AGENDA
MAY 5, 2026
LAVON CITY COUNCIL
CITY HALL, 120 SCHOOL ROAD, LAVON, TEXAS
REGULAR MEETING
6:30 PM

C. Approve the preliminary plat of the 205-78 Addition consisting of two commercial lots on 5.133 acres out of the W.A.S. Bohanan Survey, Abstract No. 121, situated south and west of the intersection of SH 78 and SH 205and north and east of Grand Heritage - West C Addition, City of Lavon, Collin County, Texas (CCAD Property IDs 2675083, 2826863, 2882966, and 2664025).

C. Discussion and action regarding the preliminary plat of the Elevon Section 3A Addition, Phases 3A-1, 3A-2, 3A-3, 3A-4, and 3A-5 consisting of 561 residential lots, 1 amenity center common area, 1 wastewater lift station lot, and 22 common areas on 172.014 acres out of the Samuel M. Rainer Survey, Abstract No. 740, situated adjacent to and east of Elevon, Section 2, Phase 2E north of the extension of Elevon Parkway, City of Lavon, Collin County, Texas (CCAD Property IDs 2961759 and 1290034).

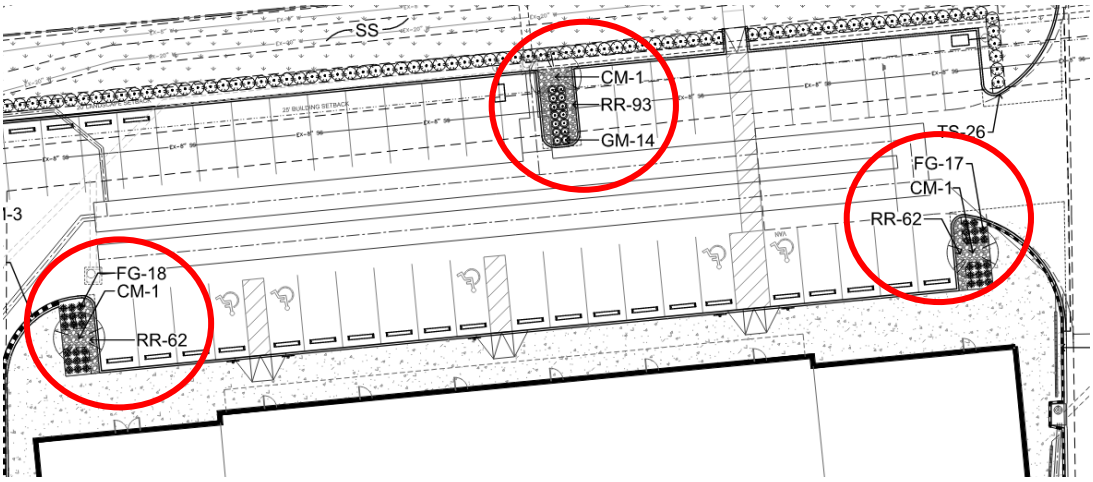
Ordinance. Revise the Landscape Plan to provide an approved canopy tree within these locations. An example is shown below.
